APPLICATION FOR CLASSIFICATION AS HARDSHIP GAS WELL

Lease San Juan 29-5 Unit Well No. 89 UT K Sec. 34 TWP 29N RGE 5W

Re: San Juan 29-5 Unit #89 Dakota

MLF PER MONTH

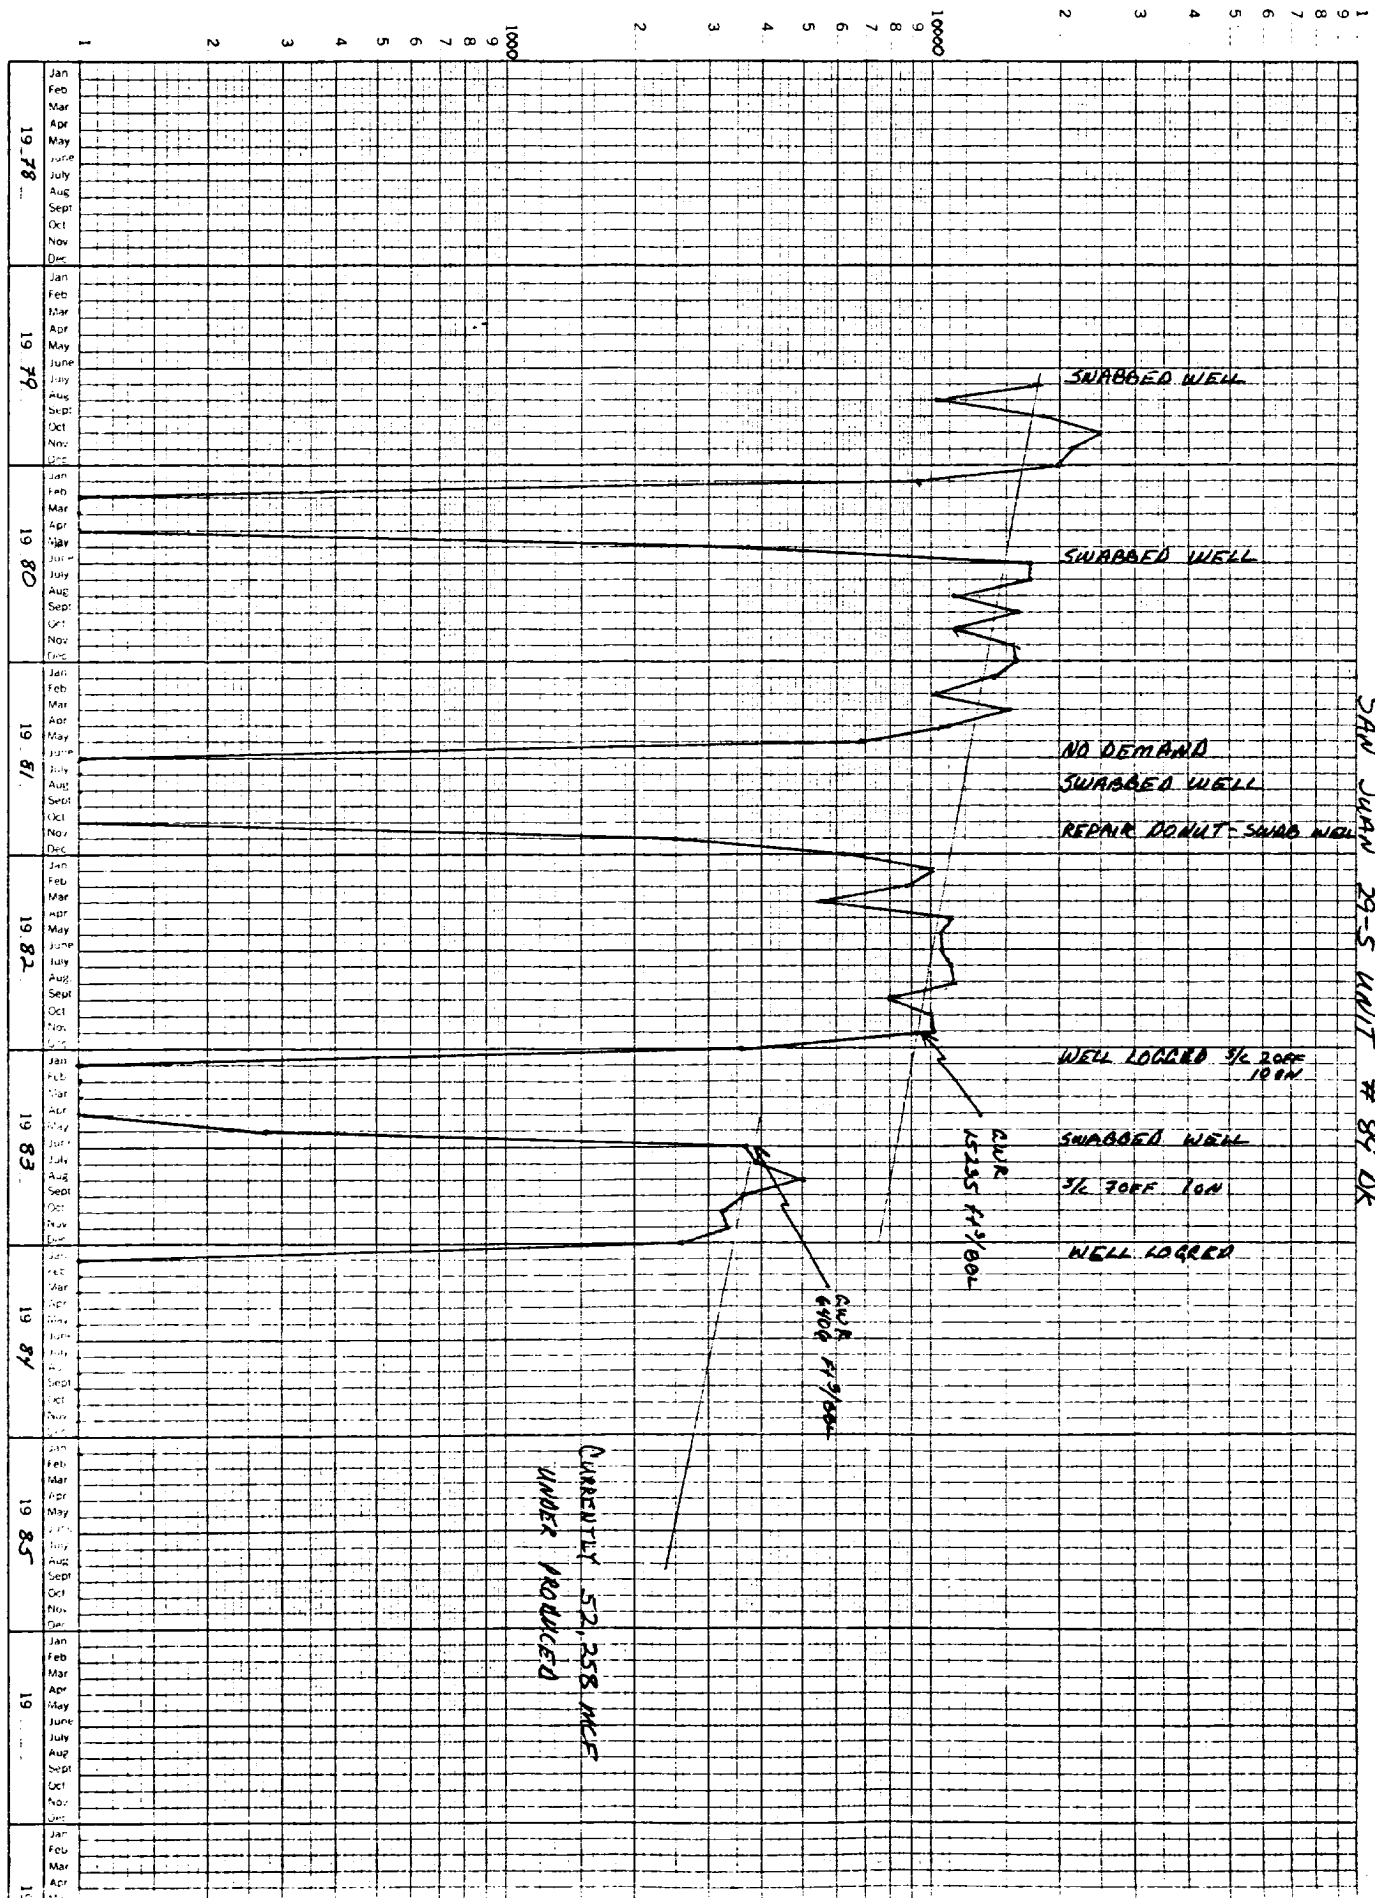
- ① Smaller tubing has not been installed
- ② Water production has never been reported on C-115's
- ③ Declining pressure while S. I. may indicate casing failure and could account for fast production drop off.
